phone 614.410.4600 fax 614.410.4747 www.dublinohiousa.gov City of Dublin Planning and Zoning Commission

Planning Report

Wexford Estates Subdivision – Lot 14 6369 Angeles Drive

Case Number 15-058AFDP/FP

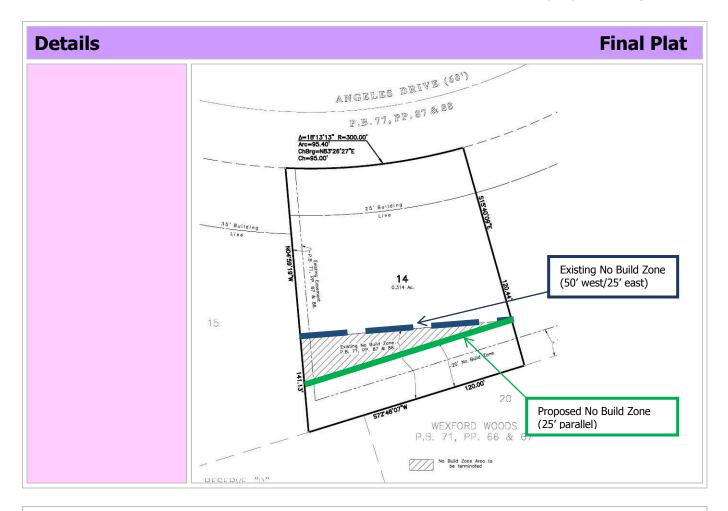
Plat Detail	As proposed, the existing No Build Zone (see graphic on next page) would be removed and the new No Build Zone would be 25 feet wide and parallel to the rear lot line.
